### Salz Proposal Written Deputation – Height & Density

**Figure 1: Salz Proposal vs. Secondary Plan Limits**

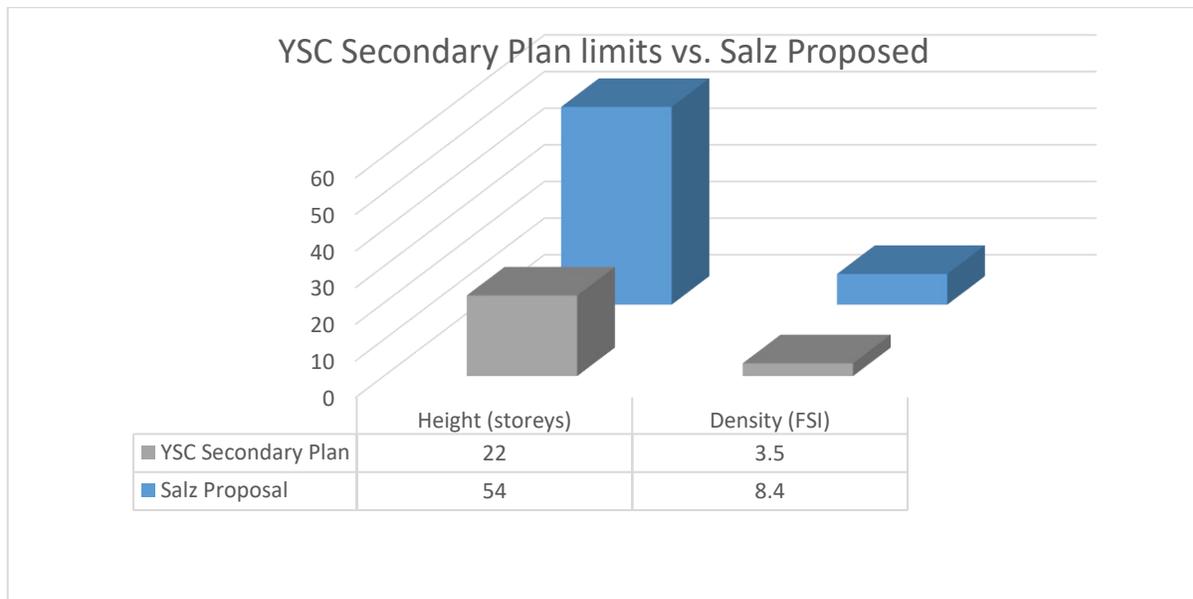
Figure 1 graphically shows the disproportionate difference between the Secondary Plan limits in height and density and Salz's proposal – maximum height of 54 storeys vs. 22 allowed (245 % higher), and density of 8.4 versus 3.5 allowed. (240% higher). Double the height and over double the density.

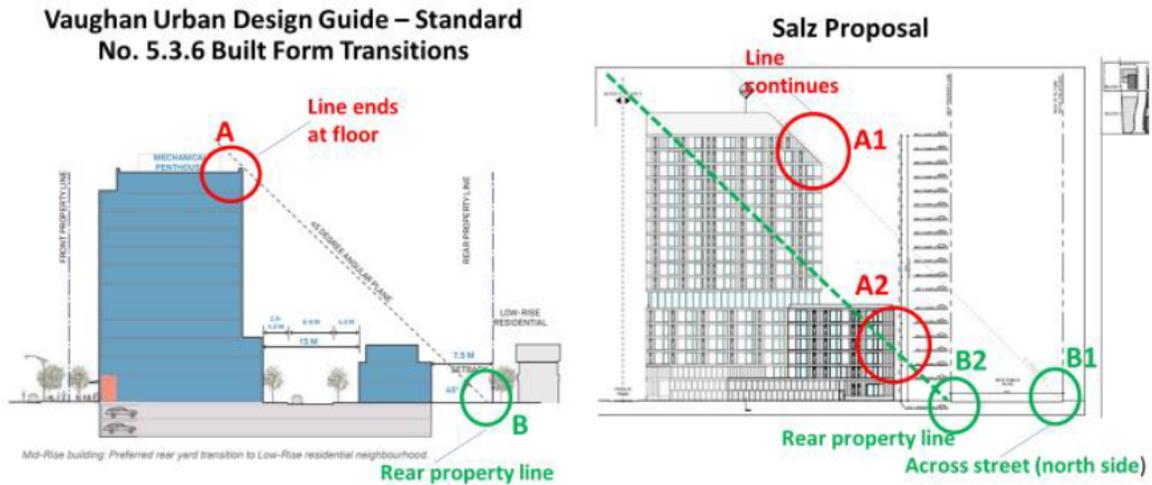
There is another matter which I wish to bring to your attention on the proposal, as shown in Figure 7. The City's Urban Design Guide requires a 45 Degree Angular Plane from residential areas towards the nearest new building, starting at the rear property line.

If you look at the right side of that figure, you will see that the Salz proposal, you will see that the 45 degree angle, marked as B1, actually starts 33 feet further north, on the north side of Royal Palm, which would be city property, and the 45 degree line intersects the mid-rise building at the 16<sup>th</sup> floor (A1). You will also see that unlike the Design Guide, which cuts off the building height at the 45 degree line intersect, the building has two extra floors using an 45-dgree angled wall. That's the first problem.

Furthermore, if the line were actually starting at the rear property line (B2), the line in green dashes would intersect the first building at A2, the 3<sup>rd</sup> floor, meaning only a three storey height is possible.

Whether these two errors were deliberate or accidental doesn't matter, but they dramatically changes what height would be allowed with the current setback from the rear property line.

**Figure 8: Map of 54-storey buildings in Vaughan**

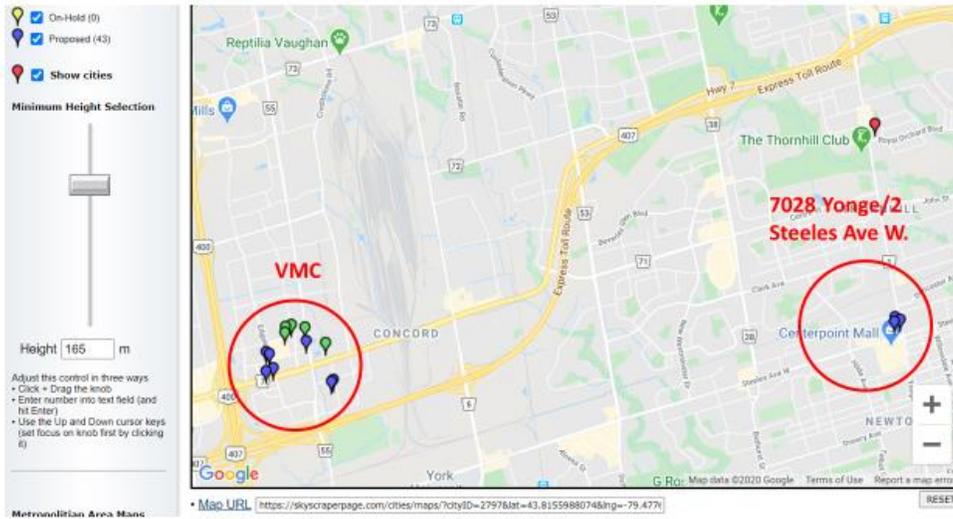
Finally, the other question that has to be asked and answered is how the proposed building heights compare to others in Vaughan, the “me too” method which is used to rationalize similar heights. Figure 8 is a map of all buildings, proposed, under construction, or built that would meet or exceed 45 storeys in Vaughan. The ONLY cluster of buildings with these heights are located in the VMC, which is of course Vaughan’s downtown and a subway terminus. The highest building at the VMC was approved at 175% of the allowed height. Salz wants 245%. The circle on the right side is Yonge & Steeles – the Gupta proposal, which is for 52 and 65 storeys. The Salz proposal hasn’t been loaded yet, so it doesn’t show up. One other interesting thing you will notice is what isn’t there – Steeles West at Black Creek Pioneer Station. In fact, the tallest building at or around that station is 4001 Steeles Ave West, at 17 stories.

Figure 9: - Salz proposed heights compared to City of Toronto locations

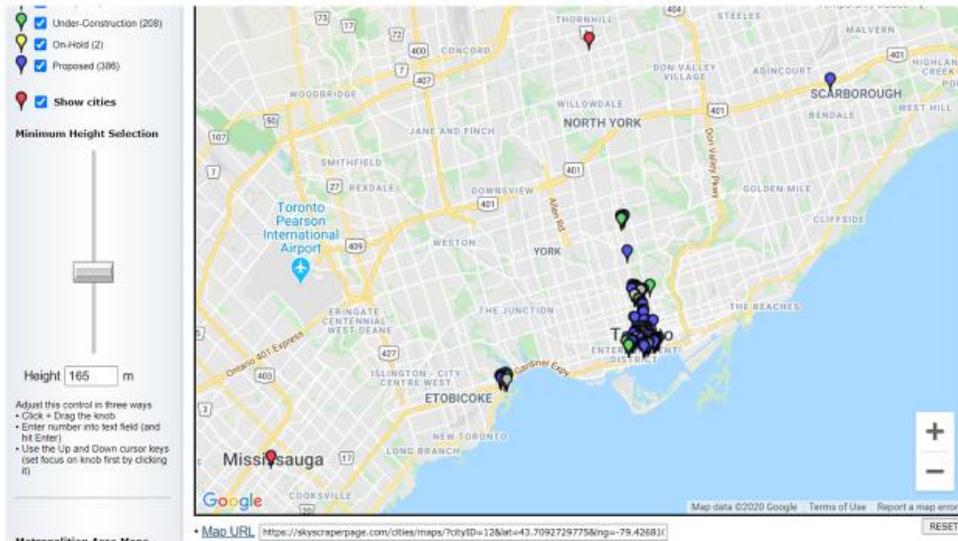
Yonge-Steeles may be a cross-road of two major arteries, and straddle three municipalities, but it is NOT the VMC, it's NOT Yonge & Sheppard, it's NOT Yonge & Eglinton. Its proposed subway station is not a terminus, nor does it have another subway or LRT line running across Steeles, nor is Centrepoint a major regional mall like Scarborough Town Centre. So let's be realistic in our comparisons, and not fall into Edifice Complex. Unless you want to relocate the Vaughan Metropolitan Centre to Yonge & Steeles, I
